DEVIATION REQUEST AND DECISION FORM

Project Name : Waterbury Filing No. 1
Schedule No.(s) : 4200000417
Legal Description : Waterbury Filing No. 1

A deviation from the standards of or in Section **DCM 10.5.4, 10.7, and DCM Update 9.0-9.1 per ECM 3.3.3.B.** is requested.

WATERBURY FILING NO. 1
CONSTRUCTION SET
WEST CHANNEL - CHANNEL IMPROVEMENTS PLAN

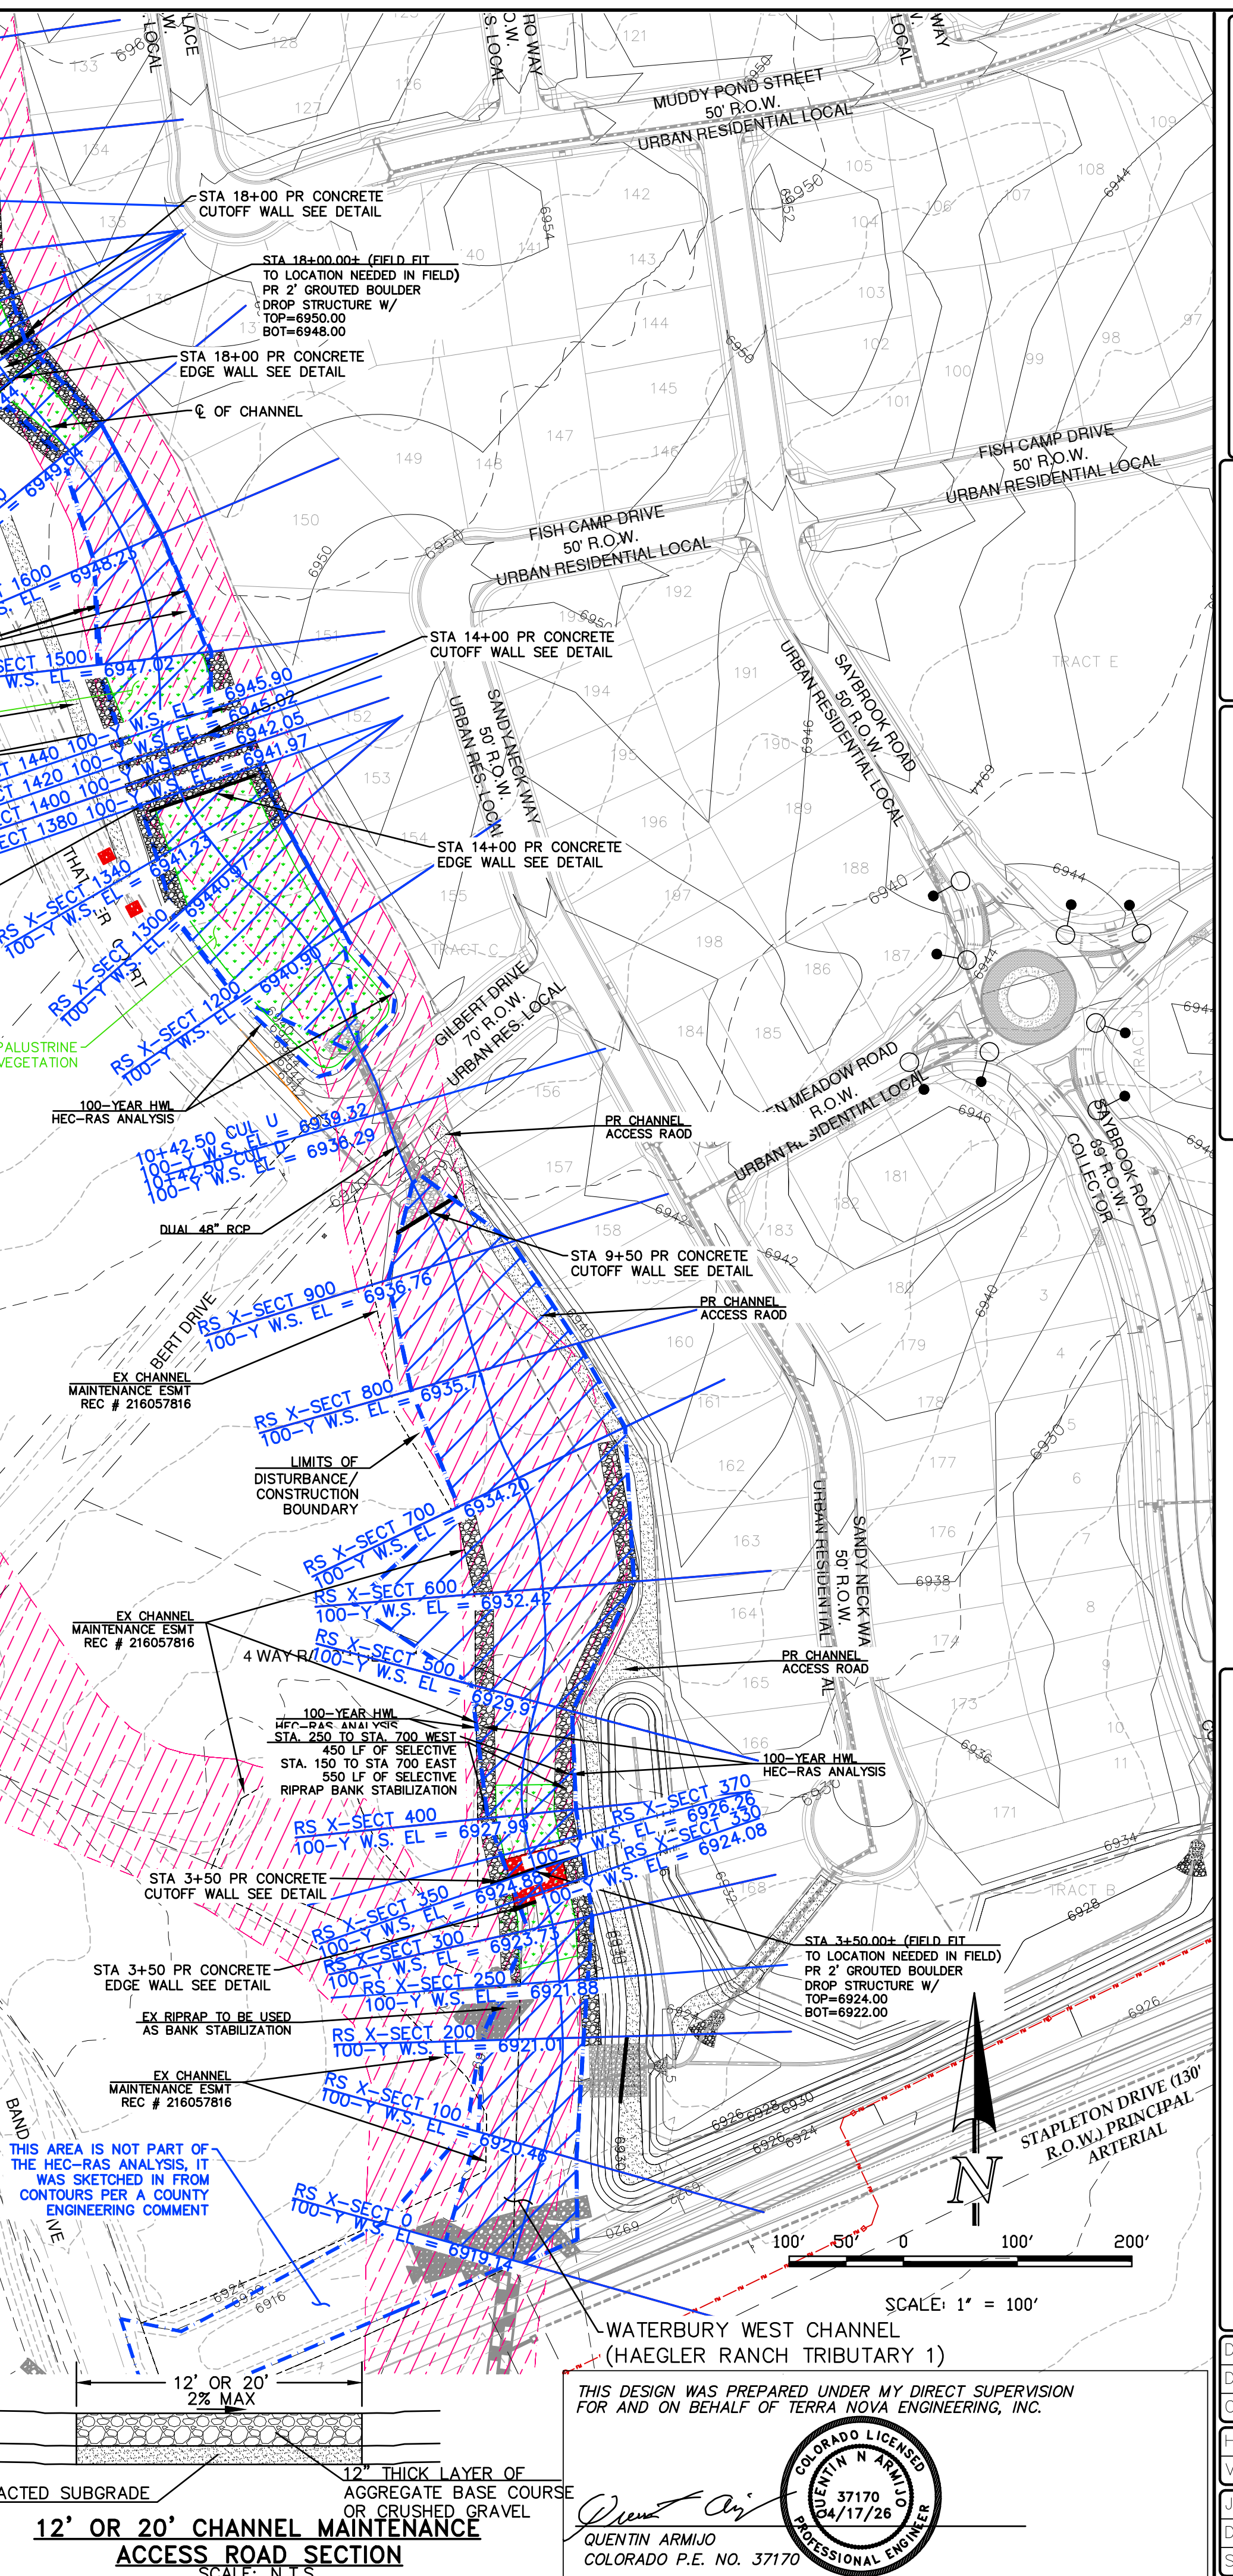
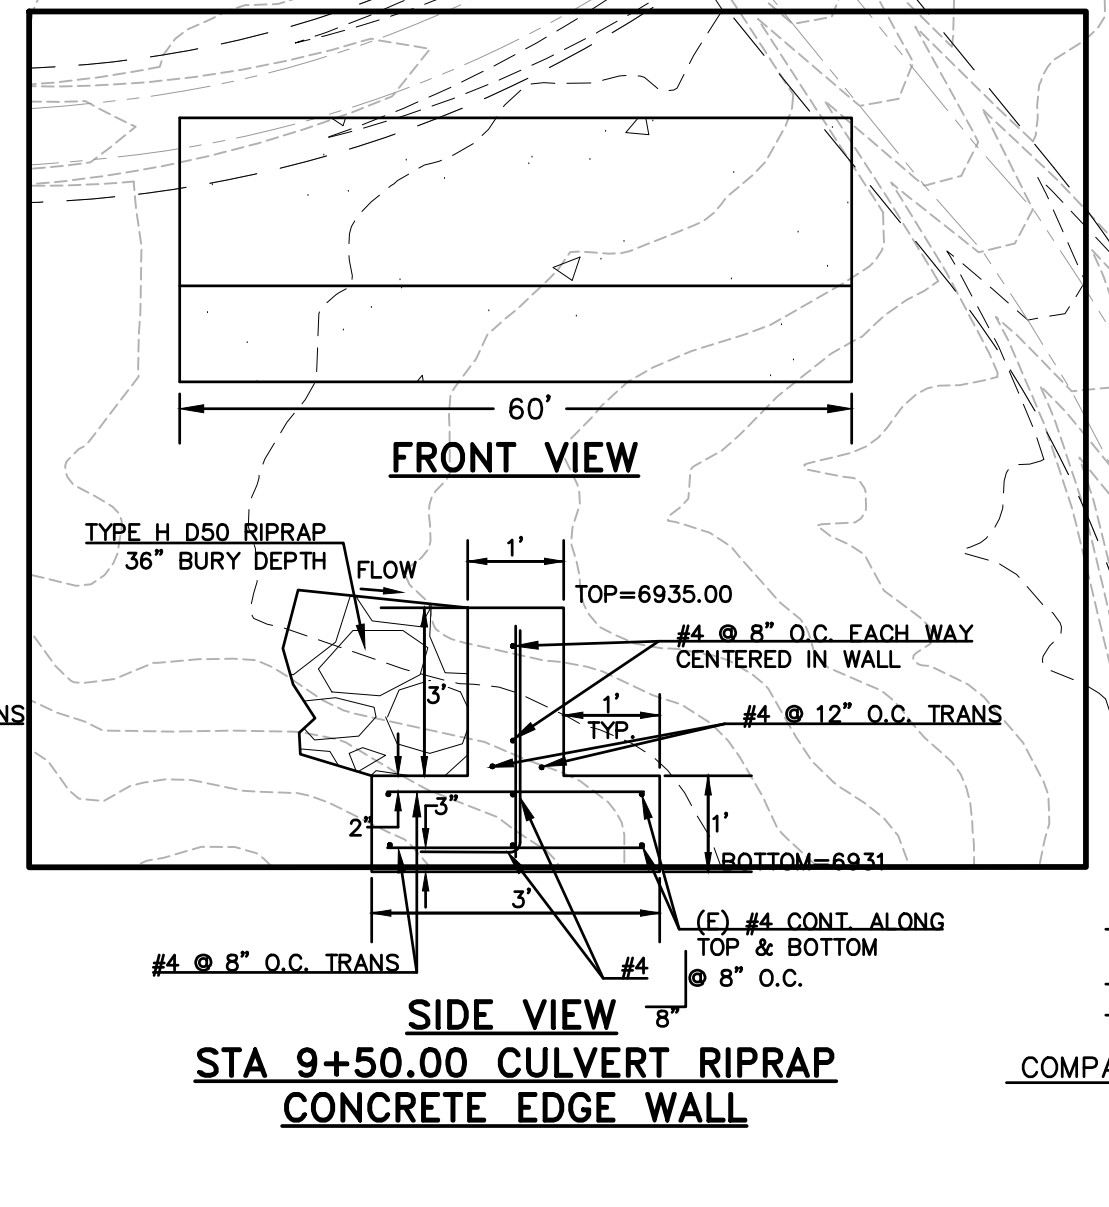
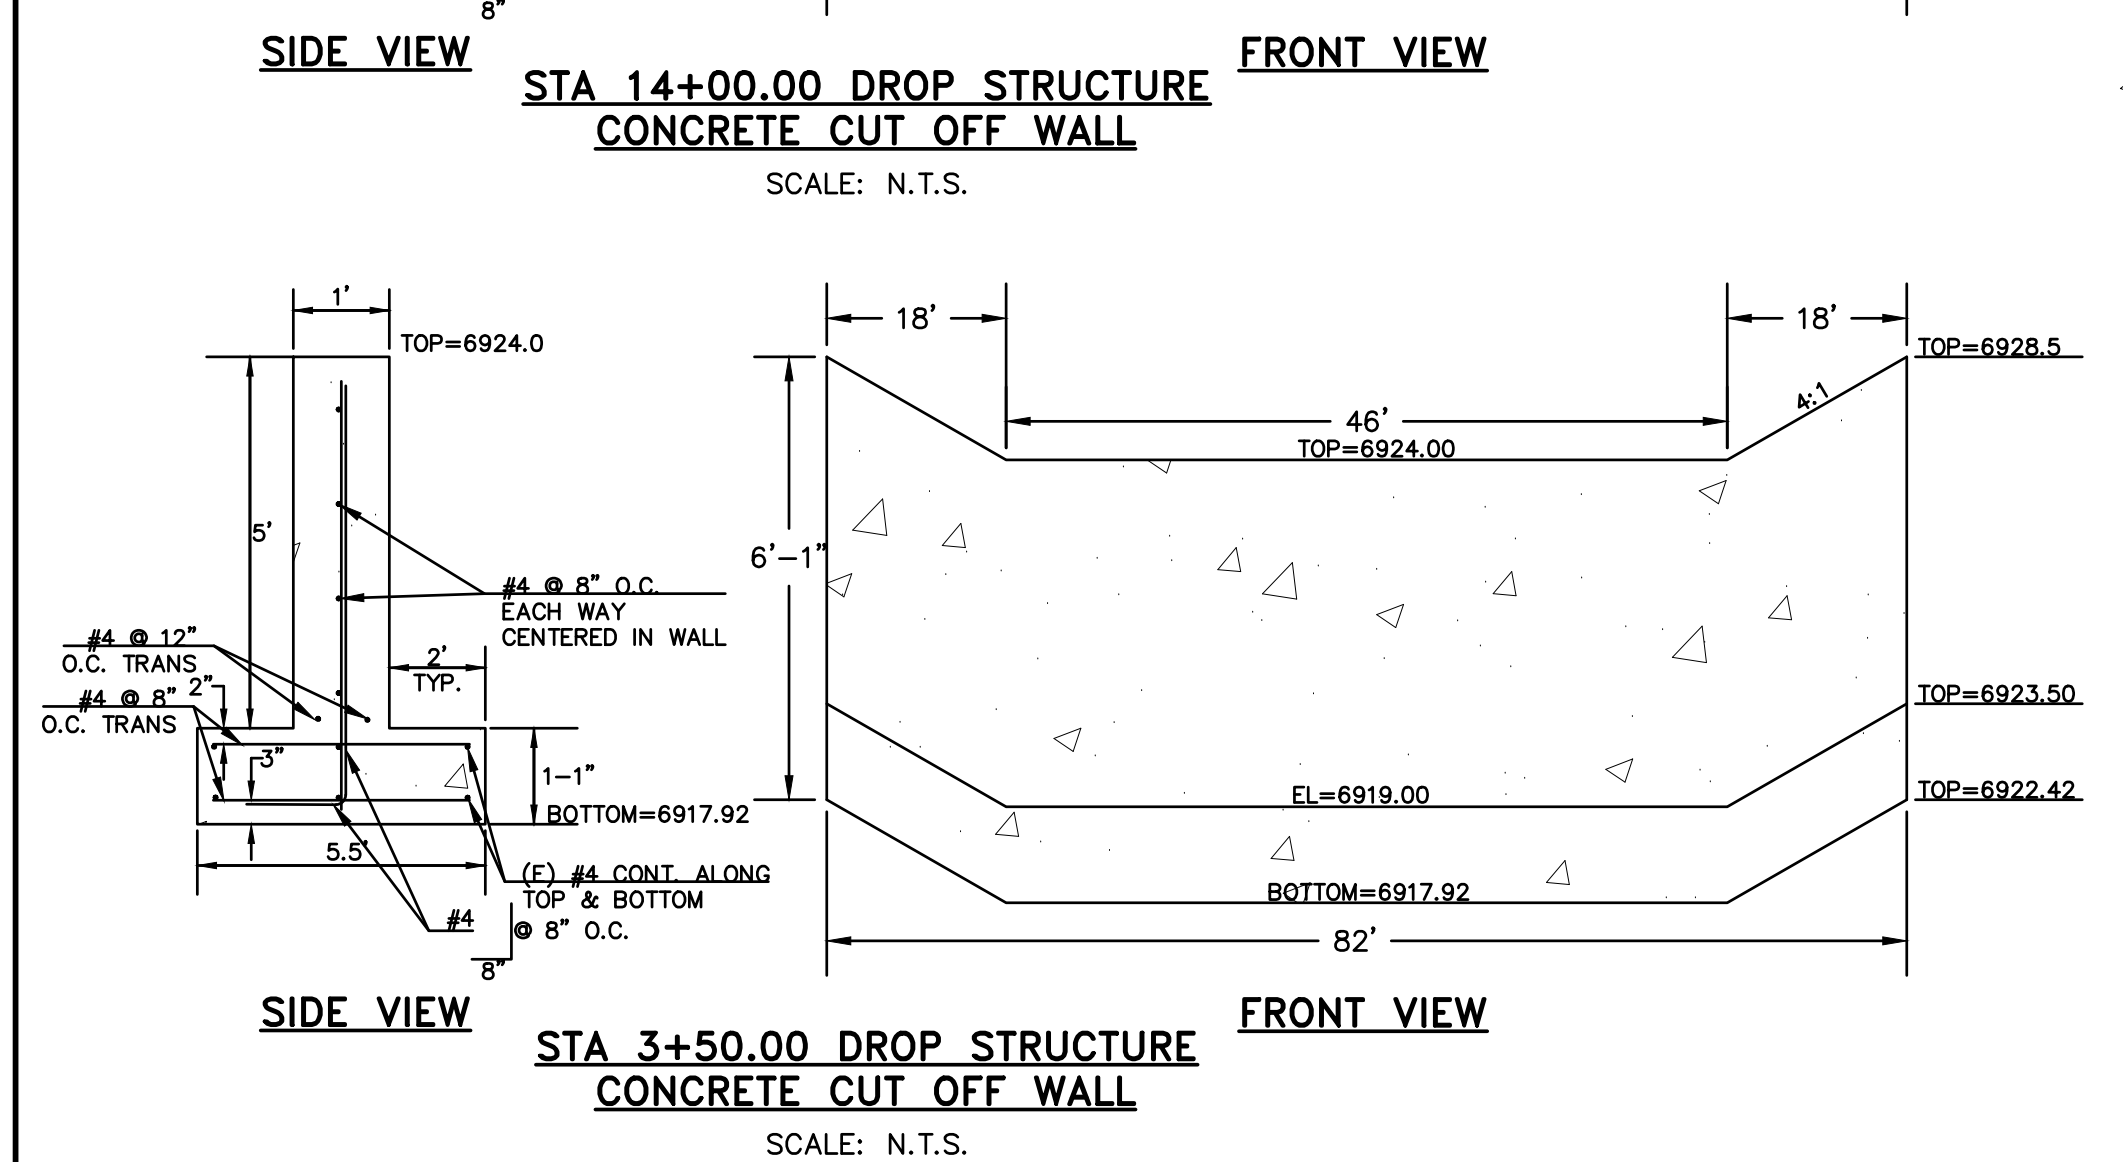
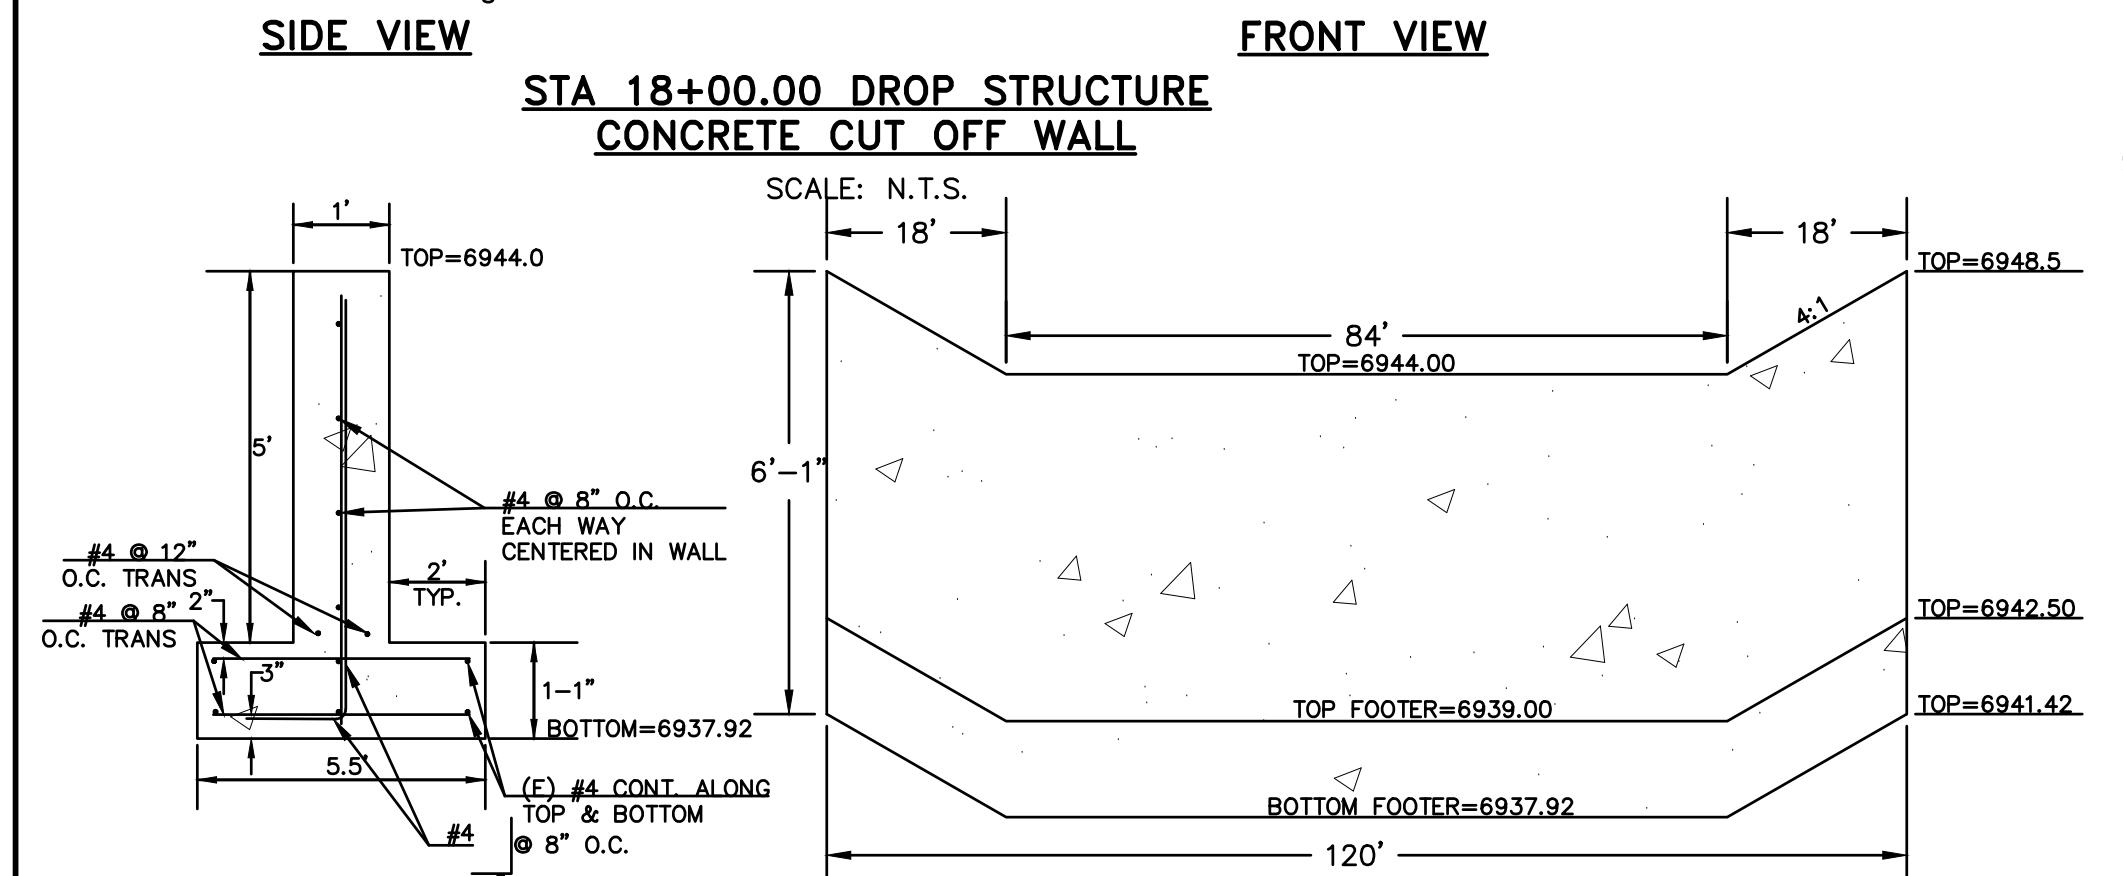
An alternate for the West Channel in the 100-Year event is to armor the channel sides, provide drop structures and plant cattails and palustrine emergent wetland vegetation. We are proposing to do just that with the construction drawings at these locations listed below in the 100-Year event.

In the 100-y event RS x-section **1820** is shown as supercritical the velocity is 5.06 fps, the Froude number is 0.91 and the shear stress is 2.63 lbs/sq ft, this cross section is at the top of a proposed grouted riprap drop structure with armoring on the sides and being re-vegetated. This is the proposed alternative to resolving the issue.

In the 100-y event RS x-section **1800** is shown as supercritical the velocity is 5.25 fps, the Froude number is 1.01 and the shear stress is 2.98 lbs/sq ft, this cross section is a proposed grouted riprap drop structure with armoring on the sides and being re-vegetated. This is the proposed alternative to resolving the issue.

In the 100-y event RS x-section **1420** is shown as supercritical the velocity is 4.00 fps, the Froude number is 1.01 and the shear stress is 2.07 lbs/sq ft, all below the erosive limits shown in Table 8.3 this cross section is a proposed grouted riprap drop structure with armoring on the sides and being re-vegetated. This is the proposed alternative to resolving the issue.

In the 100-y event RS x-section **350** is shown as supercritical the velocity is 5.25 fps, the Froude number is 1.01 and the shear stress is 8.09 lbs/sq ft, this cross section is a proposed grouted riprap drop structure with armoring on the sides and being re-vegetated. This is the proposed alternative to resolving the issue.
